COUNTAX®

SERVICE BULLETIN

14-T3-27

MODELS CONCERNED: MK3 Scarifier, 300 Litre PGC & Spreader

Cable Plug

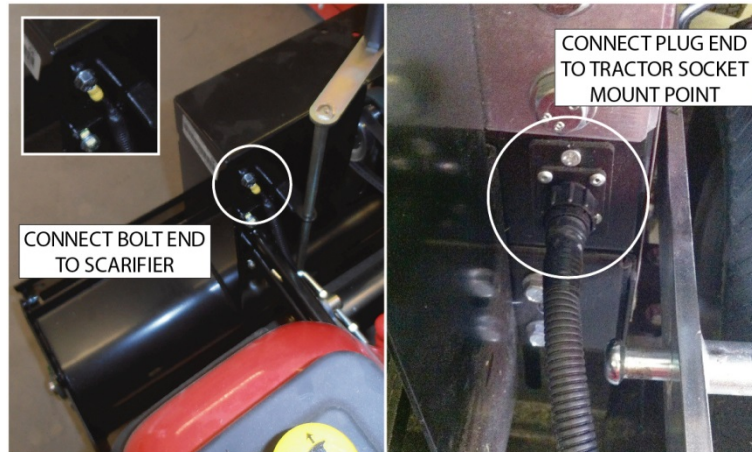
The 2014 MK4 tractor is designed with added safety features not found on earlier models. 2014 rear mounted, belt driven accessories will not function without a safety cut out switch that plugs into a rear tractor port.

Accessories made before 2014 lack the necessary cut out switch and will require a cable plug to function with the new tractor.

1. Fit the loop end to the accessory (PGC / Scarifier / Spreader).
2. Secure the cable plug using the unused bolt hole and kit fixings (see diagrams below).
3. Link the plug to the tractor by connecting the plug end with the tractor socket mount (see diagram below).
